**SERIES 100 - PRELIMINARY
COMPARISON TO ORIGINAL DESIGN
GENERAL ARRANGEMENT**

Drawing Number: 50679-BUR-XX-XX-DR-Z-0001

Revision: P 1 - REVISED FOLLOWING CHANGES

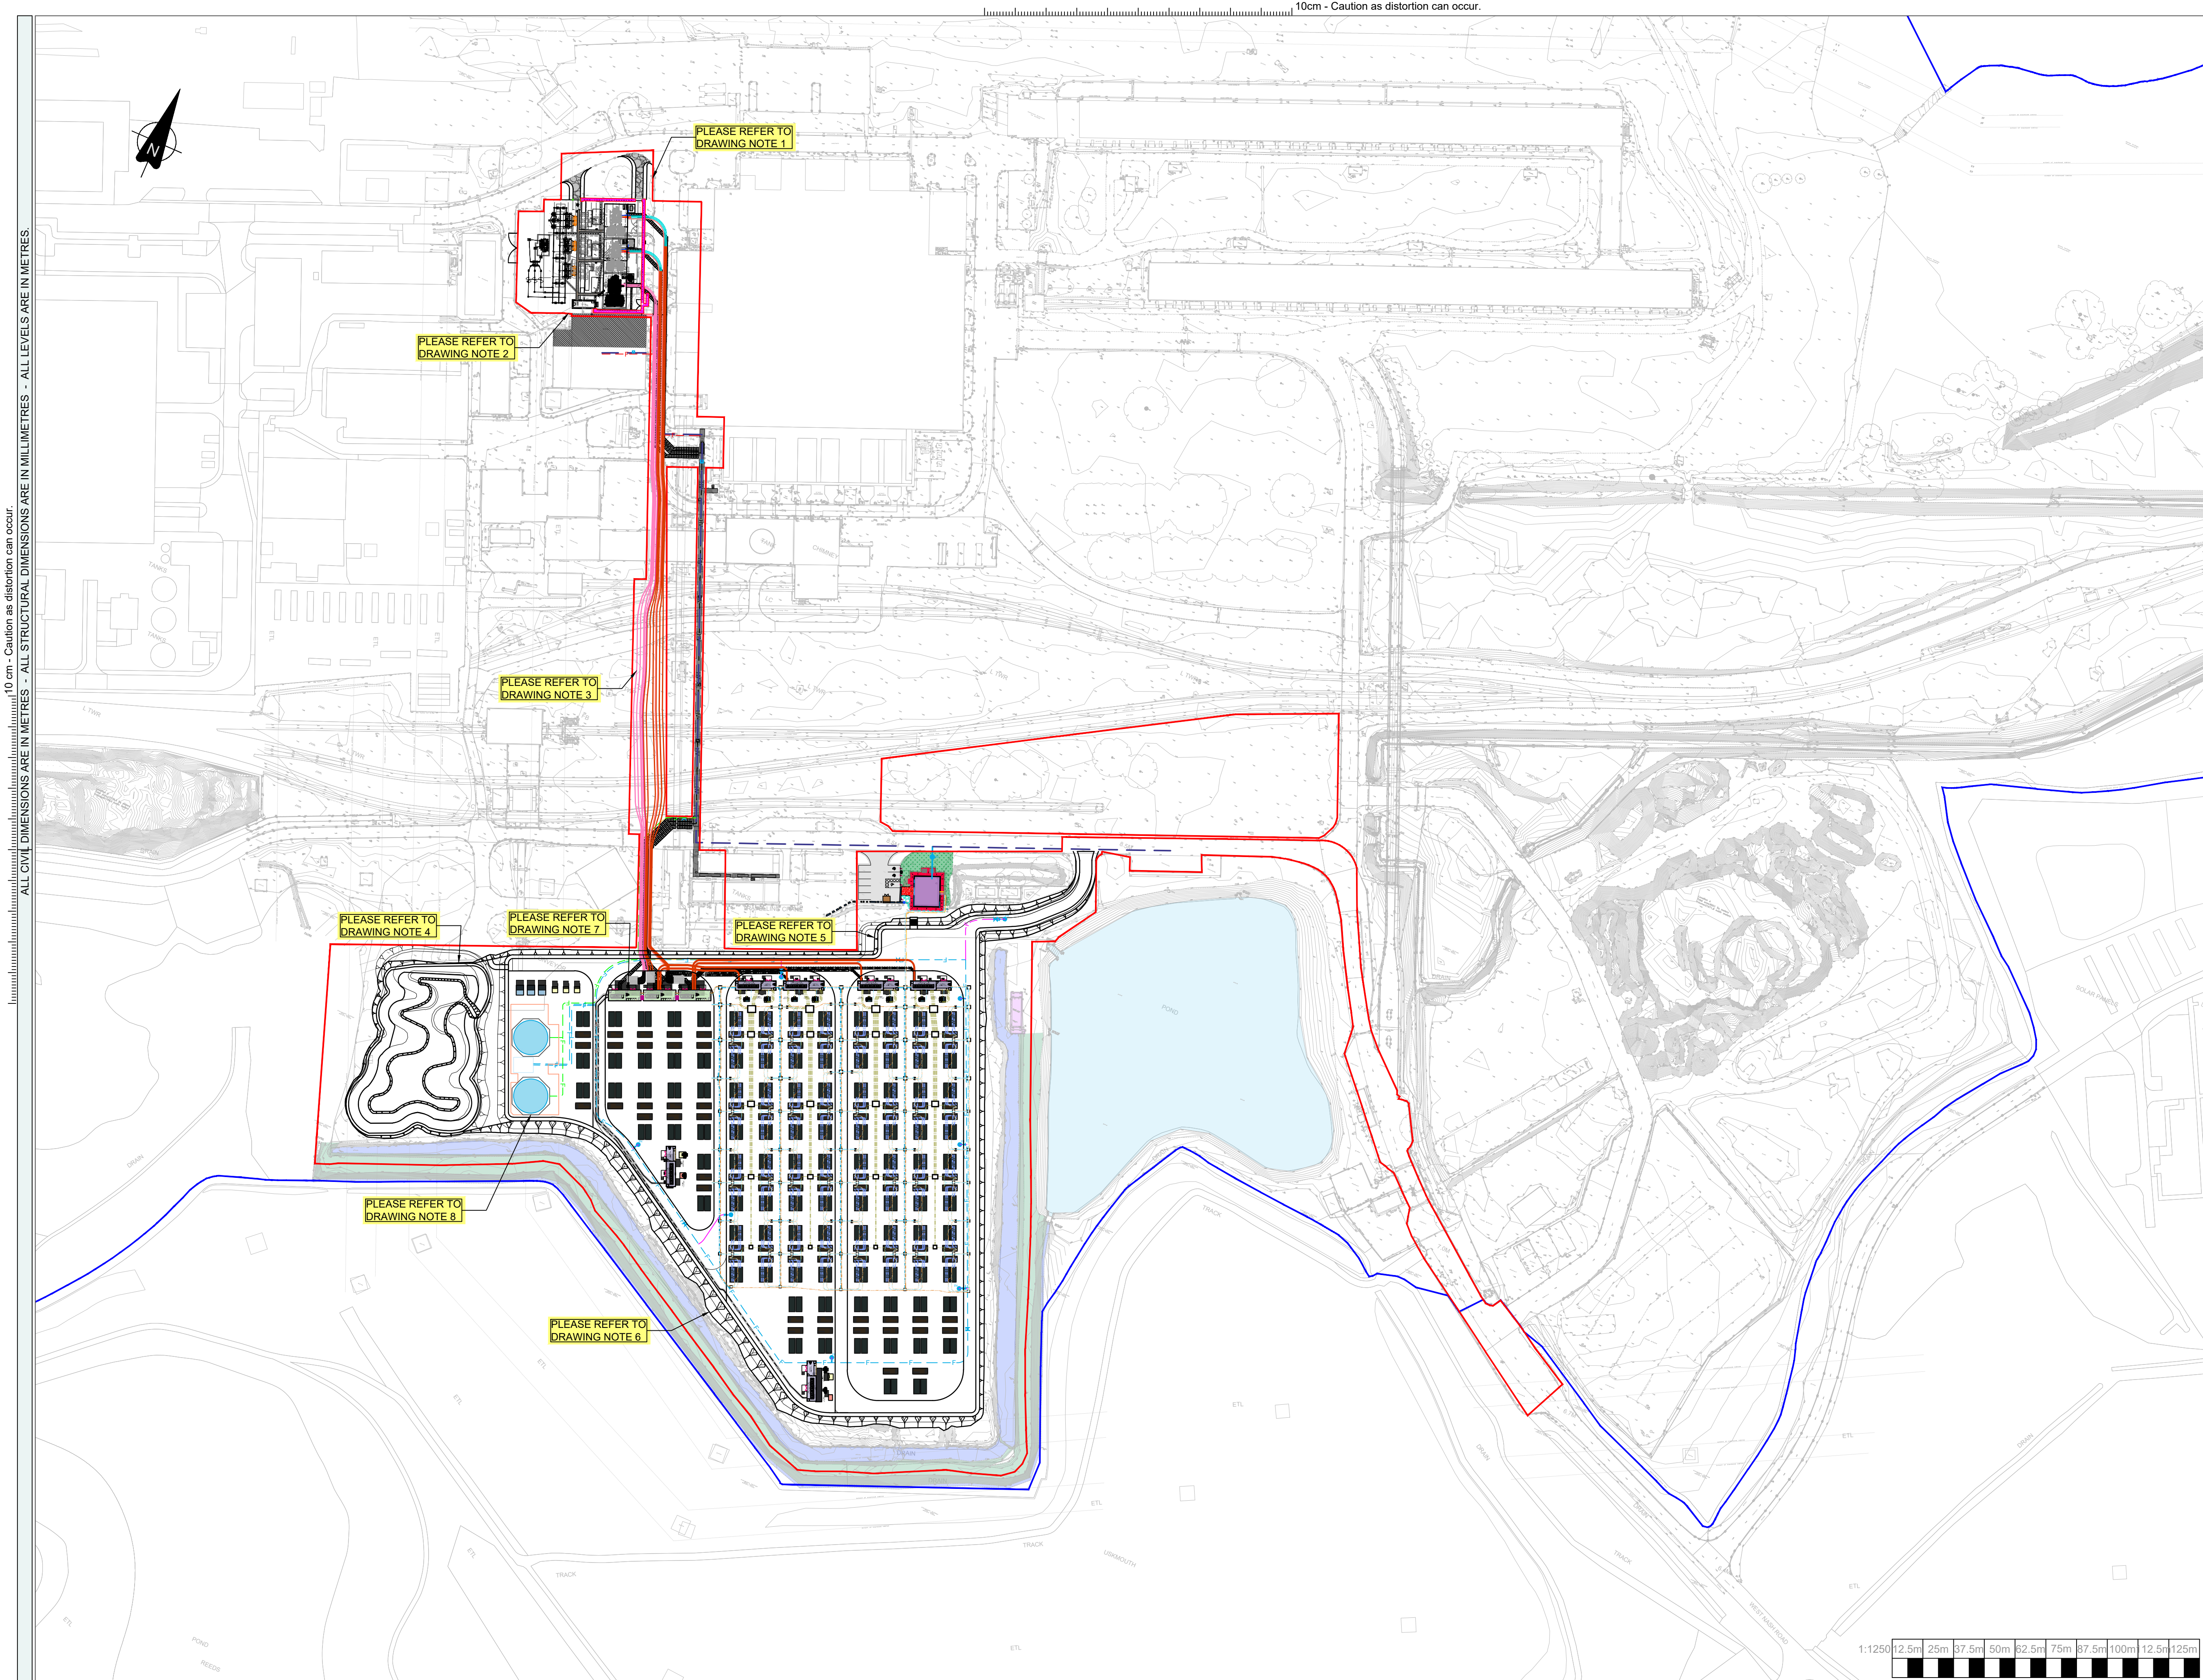
- DRAWING NOTES:**
1. PLANNING BOUNDARY UPDATED TO INCLUDE PROPOSED ACCESS ROADS AND GATES INTO THE BANKING COMPOUND.
 2. BANKING COMPOUND LAYOUT HAS BEEN ADJUSTED AS DESIGN REQUIREMENTS HAVE PROGRESSED. LEVELS WITHIN THE BANKING COMPOUND HAVE BEEN RAISED AND BANKING COMPOUND FENCING LOCATION ADJUSTED TO SUIT SPACING REQUIREMENTS.

3. PLANNING BOUNDARY UPDATED TO INCORPORATE HV ROUTE DESIGN AMENDMENT. HV ROUTE DESIGN BETWEEN BANKING COMPOUND AND BESS PLATEAU HAS BEEN AMENDED. THE HV ROUTE NOW AVOIDS THE USE OF THE TUNNEL, AND HAS BEEN COORDINATED TO AVOID EXISTING INFRASTRUCTURE.

4. POND DESIGN HAS BEEN AMENDED TO BE LOCATED OUTSIDE OF ELECTRICAL PYLON EXCLUSION ZONE, WHILST MAINTAINING REQUIRED ATTENUATION VOLUMES.
 5. PROPOSED BESS PLATEAU EARTHWORKS ADJUSTED TO BE LOCATED AWAY FROM EXISTING COAL HOPPER CHUTE, AND THEREFORE LIMIT ANY IMPACT ON STRUCTURE.

6. PROPOSED BESS PLATEAU EARTHWORKS ADJUSTED TO REMOVE REQUIREMENTS FOR GEOTEXTILE REINFORCEMENT. EARTHWORK SLOPES SLACKENED TO REDUCE THE REINFORCEMENT REQUIRED.

7. SUBSTATION BUILDING POSITIONS ADJUSTED TO AVOID CLASHING WITH OTHER PROPOSED INFRASTRUCTURE, AND ENSURE DESIGNS ARE COORDINATED.
 8. PROPOSED FIRE WATER TANKS HAVE BEEN ADDED TO THE DESIGNS. FIRE WATER TANKS ARE REQUIRED, AS TANKS WITHIN THE EXISTING FIRE BUILDING ARE NO LONGER BEING UTILISED FOR THE PROJECT.
